INDIANA DEPARTMENT OF ENVIRONMENTAL MANAGEMENT

Re: NPDES Permit No. IN0063711
ArcelorMittal Indiana Harbor, LLC –
Central Wastewater Treatment Plant
East Chicago, Indiana
Lake County

A response to the comments received pertaining to the draft NPDES permit is contained in the Post Public Notice Addendum. The Post Public Notice Addendum is located at the end of the Fact Sheet.

INDEX
for
ArcelorMittal Indiana Harbor Central Wastewater Treatment Plant NPDES Permit IN0063711

FIGURE 3

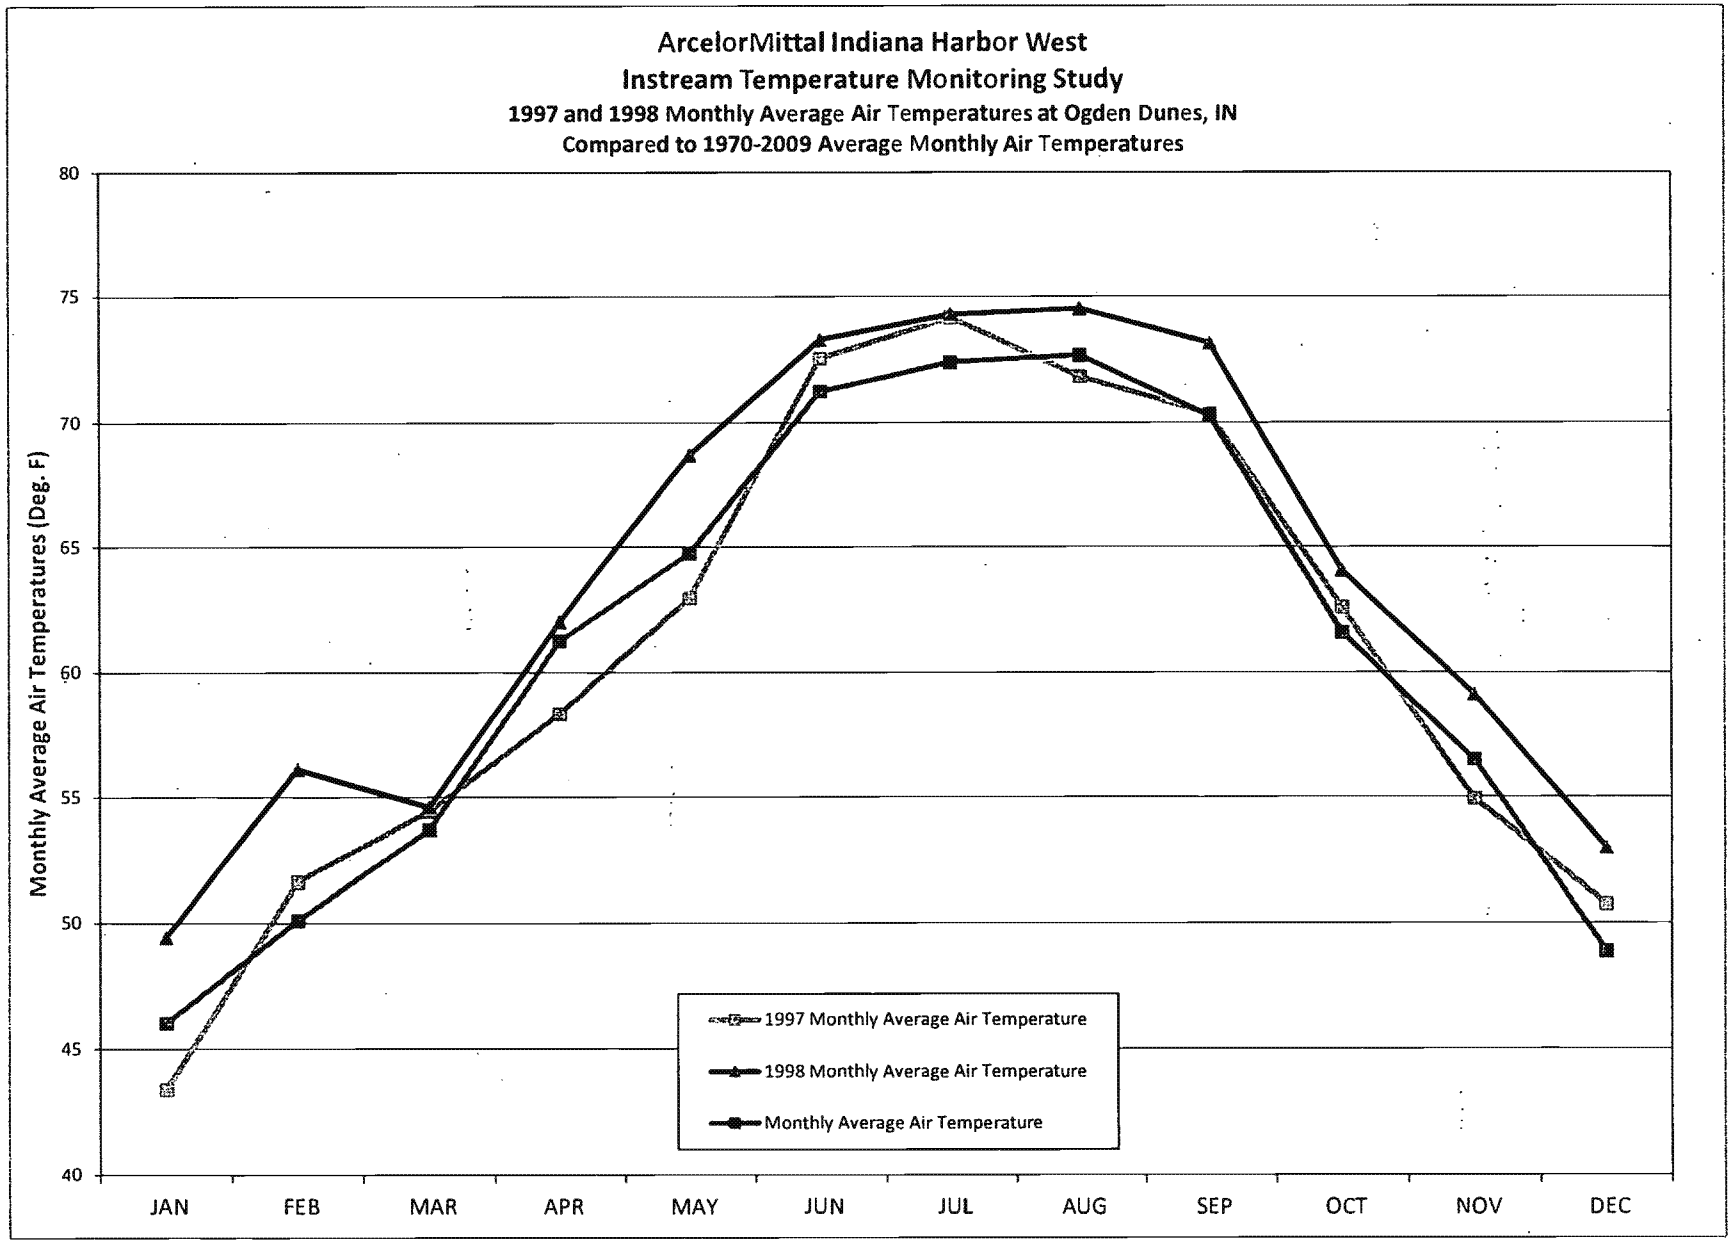
These data show ambient air temperatures in 1997 and 1998 were typical of historic conditions and suggest in-stream temperatures for 1997 and 1998 are representative of thermal discharges at the time and typical summer air temperatures. Monthly average data for January through December are included as Exhibit C and are shown graphically in Figure 3.

FIGURE IHW-1

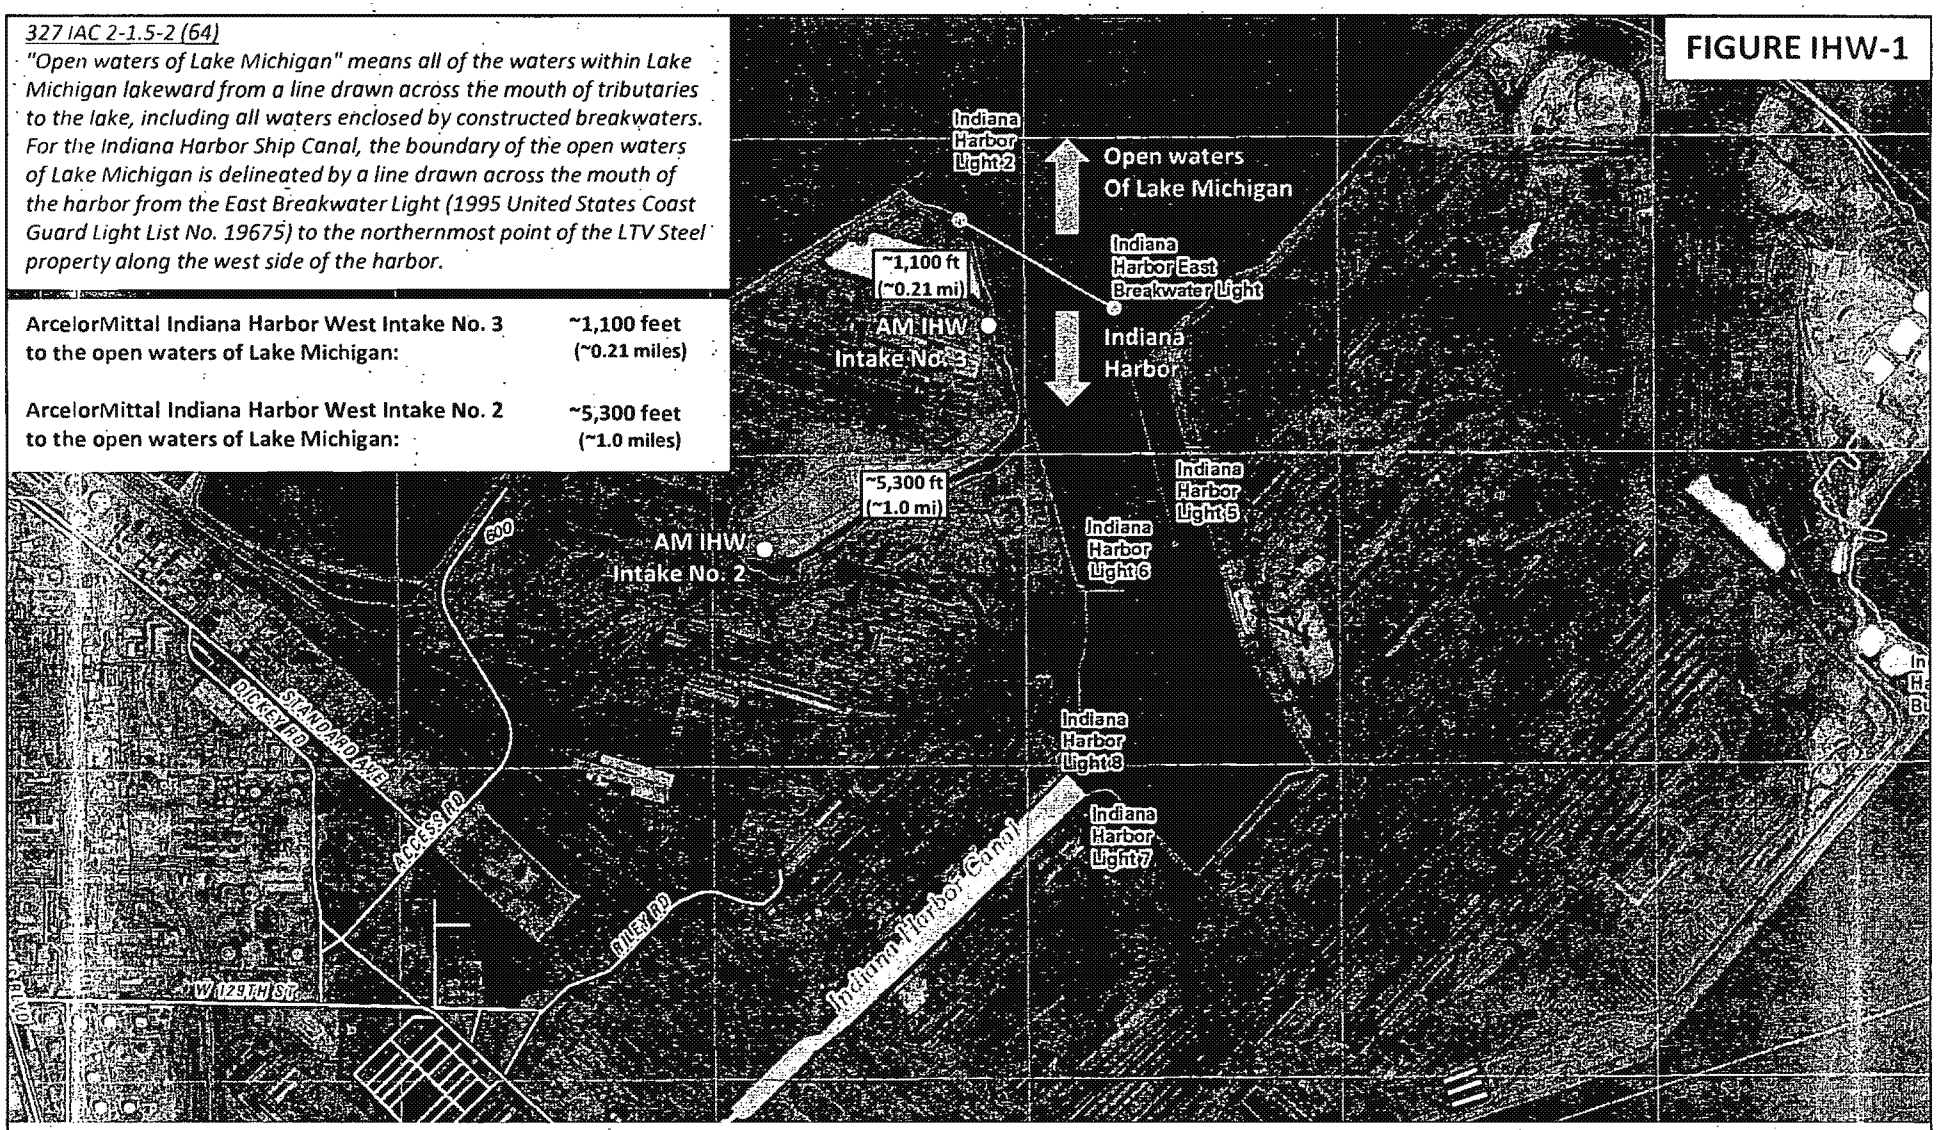
IDEM states in Attachment A of the Fact Sheet (p. 5), that Indiana Harbor West has two water intakes in Lake Michigan; and, that IDEM considers the intake channel for the Nos. 2 and 3 intakes as "open waters of Lake Michigan" (p. 12). Figure IHW-1 is an aerial photograph showing the Nos. 2 and 3 intakes, the intake channel and the northern section of the Indiana Harbor Ship canal that borders the open waters of Lake Michigan. A line depicting the boundary described in the above definition of "open waters of Lake Michigan" is shown on the aerial photograph. It is evident from a simple reading of the regulatory definition of "open waters of Lake Michigan" and review of the aerial photograph that the Indiana Harbor West intake channel and the Nos. 2 and 3 intakes are not within open waters of Lake Michigan. They are not lakeward of the line between the East Breakwater Light and the northernmost point of LTV Steel property (now ArcelorMittal Indiana Harbor LLC property). In fact, the No. 3 Intake is approximately 0.21 miles south of the northernmost point of ArcelorMittal property and the No. 2 intake is approximately 1.0 miles south and southwest of the northernmost point of ArcelorMittal property. Thus, IDEM's assertion that the intake channel for the Nos. 2 and 3 intakes are within the

ArcelorMittal Indiana Harbor West Intake No. 3 to the open waters of Lake Michigan:	**~1,100 feet (~0.21 miles)**
ArcelorMittal Indiana Harbor West Intake No. 2 to the open waters of Lake Michigan:	**~5,300 feet (~1.0 miles)**
